## PCI-SIG DRAFT ENGINEERING CHANGE NOTICE

<b>TITLE:</b>	Emergency Power Reduction mechanism with PWRBRK signal
<b>DATE:</b>	May 4, 2015
<b>AFFECTED DOCUMENT:</b>	PCI Express Card Electromechanical Specification, Revision 3.0 PCI Express Base Specification, Revision 3.1 Single Root I/O Virtualization and Sharing Specification Revision 1.1
<b>SPONSOR:</b>	NVIDIA

Figure 2-15: PWRBRK# Timing Requirement Diagram

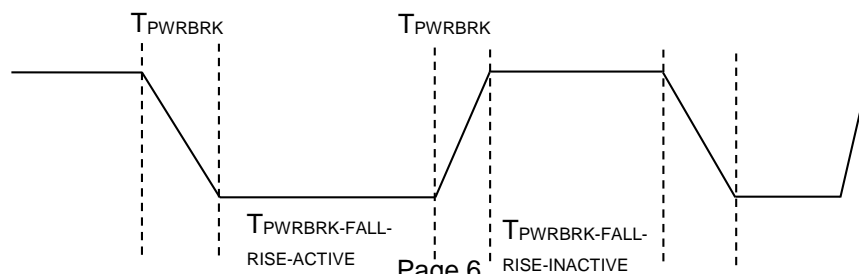
Electrical specifications for PWRBRK# at the CEM connector are defined in Table 2-3. Timing requirements are defined in Table 2-4 and Figure 2-15.

- Any supplied power is stable when it meets the requirements specified for that power supply.
- A supplied reference clock is stable when it meets the requirements specified for the reference clock. The PERST# signal is asserted and de-asserted asynchronously with respect to the supplied reference clock.
- The PERST# signal must be asserted within T<sub>FAIL</sub> of any supplied power going out of specification.
- Measured from WAKE# assertion/de-assertion to valid input level at the system PM controller. Since WAKE# is an open-drain signal, the rise time is dependent on the total capacitance on the platform and the system board pull-up resistor. It is the responsibility of the system designer to meet the rise time specification.
- Refers to timing requirement for indicating an active window.
- [Refers to PWRBRK# timing diagram in Figure 2-15.](#)

Figure 6-x Emergency Power Reduction State: Example add-in card

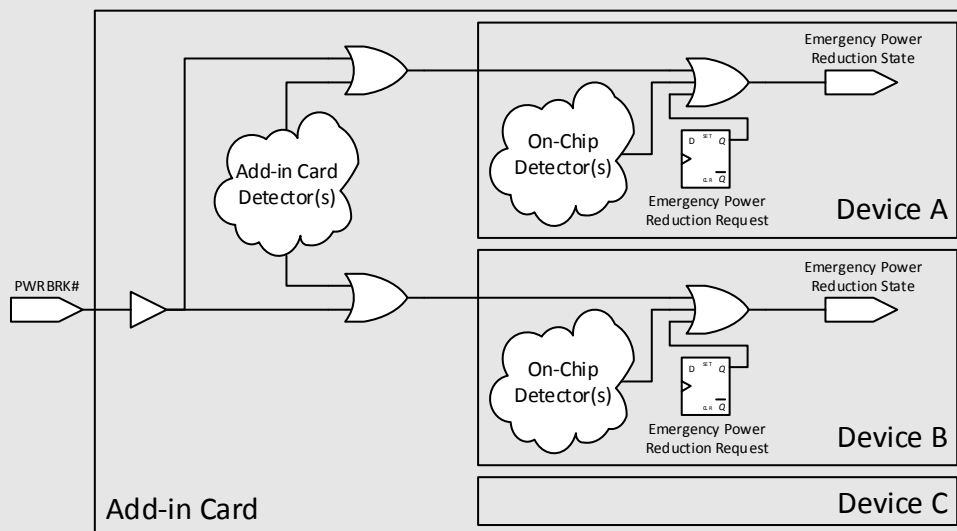
Figure 6-x shows an example multi-Device add-in card supporting Emergency Power Reduction. Note that Device C does not support the Emergency Power Reduction State. Device C might be a Switch that fans out to Devices A and B.

Figure 7-15: Device Status Register

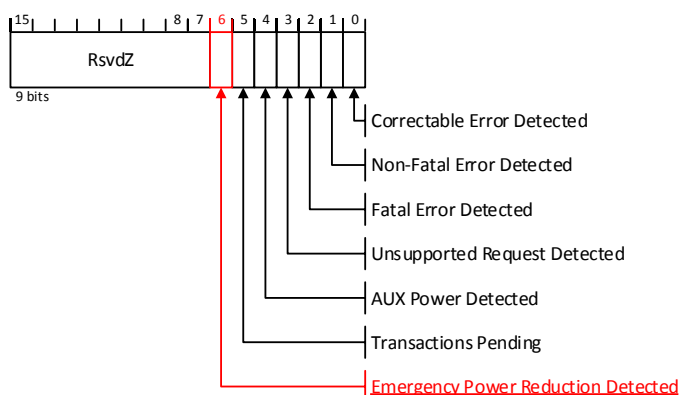
In the PCI Express Base Specification, Section 7.8.5, make the following changes:

Bit Location	Register Description	Attributes
<u>7</u>	<p><u><b>Emergency Power Reduction Detected</b> – This bit is Set when the Function is in the Emergency Power Reduction State. Whenever any condition is present that would cause the Emergency Power Reduction State to be entered, the Function remains in the Emergency Power Reduction State and attempts to Clear this bit have no effect. See Section 6.x for additional details.</u></p> <p><u>Multi-Function Devices associated with an Upstream Port must Set this bit in all Functions that support Emergency Power Reduction State.</u></p> <p><u>This bit is RsvdZ if the Emergency Power Reduction Supported field is 00b (see Section 7.8.15).</u></p> <p><u>This bit is RsvdZ in Functions that are not associated with an Upstream Port.</u></p> <p><u>Default value is 0b.</u></p>	<u>RW1C</u>

Figure 7-25: Device Capabilities 2 Register

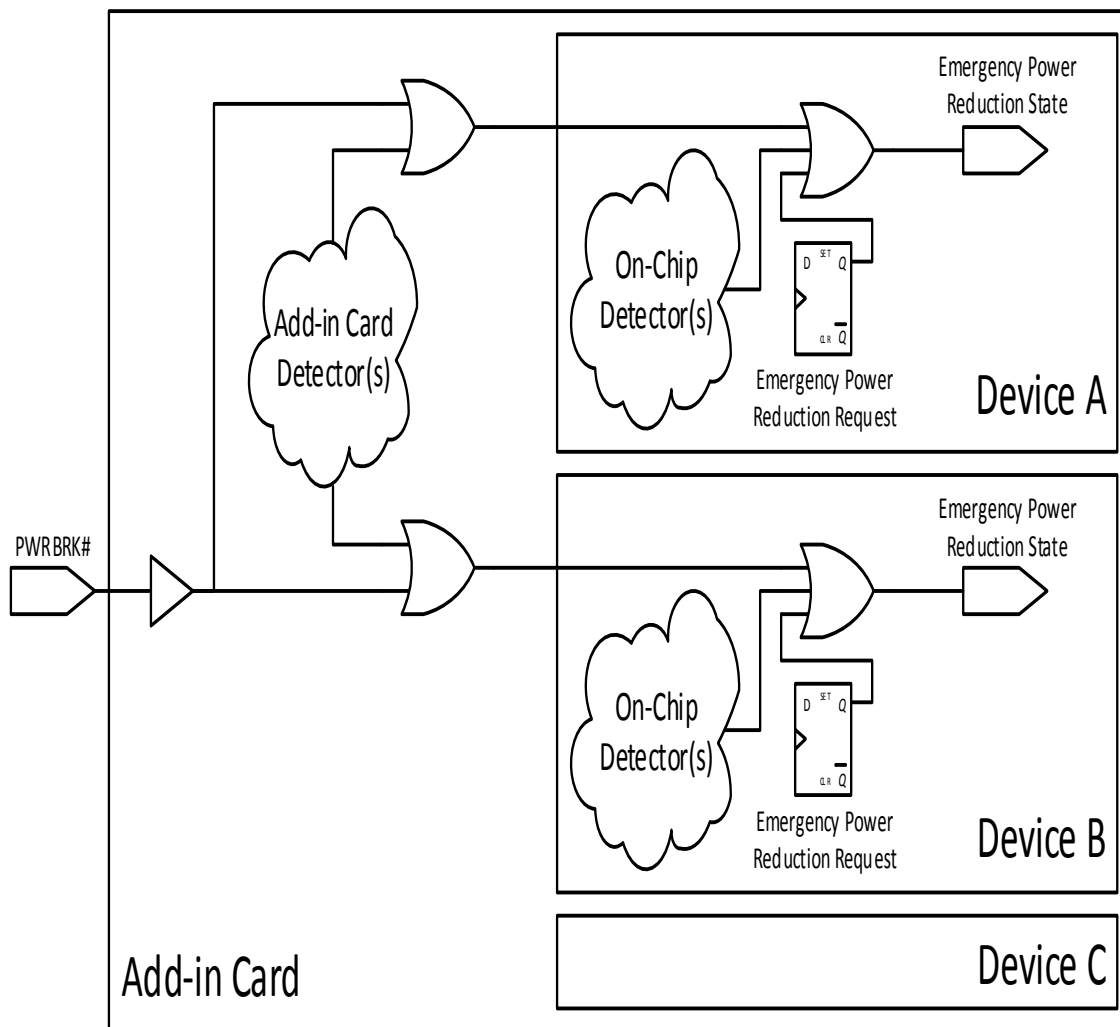
*In the PCI Express Base Specification, section 7.8.15, make the following changes:*

Bit Location	Register Description	Attributes
<a href="#">25:24</a>	<p><b><u>Emergency Power Reduction Supported</u></b> – Indicates support level of the optional Emergency Power Reduction State feature. A Function can enter Emergency Power Reduction State autonomously, or based on one of two mechanisms defined by the associated Form Factor Specification. Functions that are in the Emergency Power Reduction State consume less power. The Emergency Power Reduction mechanism permits a chassis to request add-in cards to rapidly enter Emergency Power Reduction State without involving system software. See Section 6.x for additional details.</p> <p><u>Values are:</u></p> <ul style="list-style-type: none"> <li><u>00b</u> Emergency Power Reduction State not supported</li> <li><u>01b</u> Emergency Power Reduction State is supported and is triggered by Device Specific mechanism(s)</li> <li><u>10b</u> Emergency Power Reduction State is supported and is triggered either by the mechanism defined in the corresponding Form Factor specification or by Device Specific mechanism(s)</li> <li><u>11b</u> Reserved</li> </ul> <p><u>This field is RsvdP in Functions that are not associated with an Upstream Port.</u></p> <p><u>For Multi-Function Devices associated with an Upstream Port, all Functions that report a non-zero value for this field, must report the same non-zero value for this field.</u></p> <p><u>Default value is 00b.</u></p> <p><u>After reset, once this field returns a non-zero value, it must continue to return the same non-zero value, until the next reset.</u></p>	<a href="#">HwInit</a>

<a href="#">26</a>	<p><b><u>Emergency Power Reduction Initialization Required</u></b> – If Set, the Function requires complete or partial initialization upon exit from the Emergency Power Reduction State. If Clear, the Function requires no software intervention upon exit from the Emergency Power Reduction State. See Section 6.x for additional details.</p> <p><u>For Multi-Function Devices associated with an Upstream Port, all Functions must report the same value for this bit.</u></p> <p><u>This bit is RsvdP in Functions that are not associated with an Upstream Port.</u></p> <p><u>Default value is 0b.</u></p> <p><u>After reset, when this field returns a non-zero value, it must continue to return the same non-zero value.</u></p>	<a href="#">HwInit</a>

Figure 7-26: Device Control 2 Register

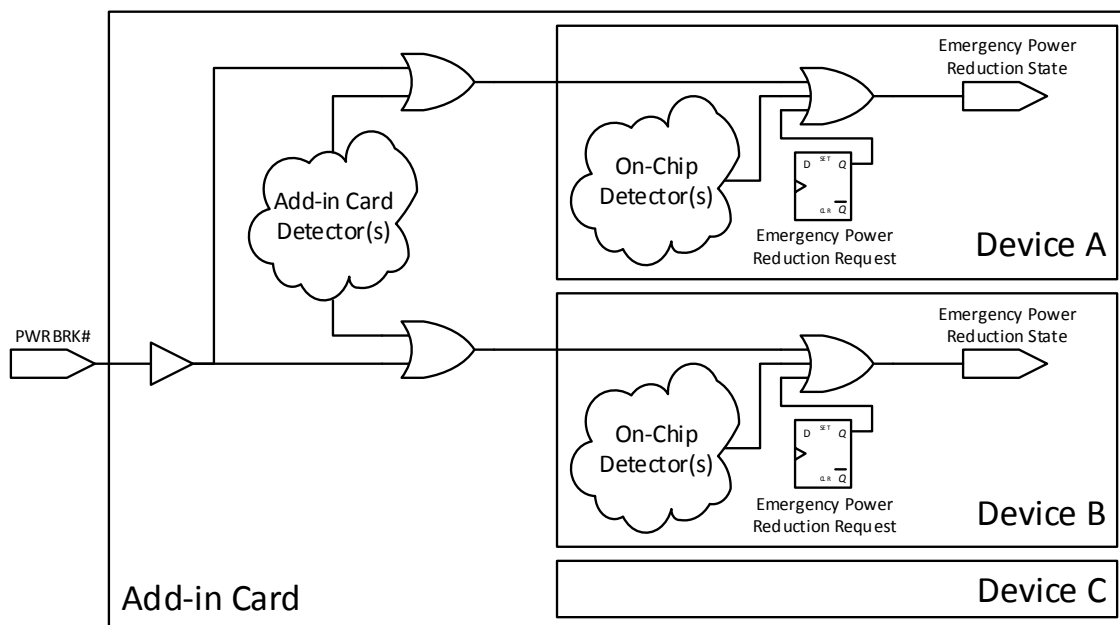
In the PCI Express Base Specification, section 7.8.16, make the following changes:

Bit Location	Register Description	Attributes
<a href="#">11</a>	<p><b>Emergency Power Reduction Request</b> – If Set, all Functions in the component that support Emergency Power Reduction State must enter the Emergency Power Reduction State. If Clear these Functions must exit the Emergency Power Reduction State if no other reasons exist to preclude exiting this state. See Section 6.x for additional details.</p> <p>This bit is implemented in the lowest numbered Function associated with an Upstream Port that has a non-zero value in the Emergency Power Reduction Supported field. This bit is RsvdP in all other Functions.</p> <p>Default is 0b.</p>	<a href="#">RW / RsvdP</a>

**Figure 3-8: Device Status Register**

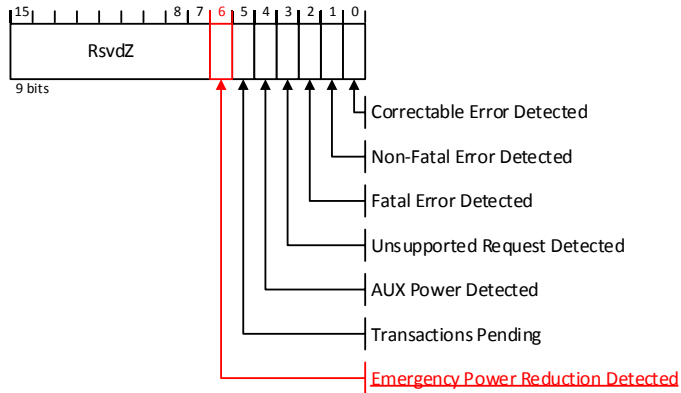
*In the Single Root I/O Virtualization and Sharing Specification, section 3.5.5, make the following changes:*

Bit Location	PF and VF Register Differences From Base	PF Attributes	VF Attributes
4	AUX Power Detected	Base	0b
<u>6</u>	<u>Emergency Power Reduction Detected</u>	<u>Base</u>	<u>0b</u>
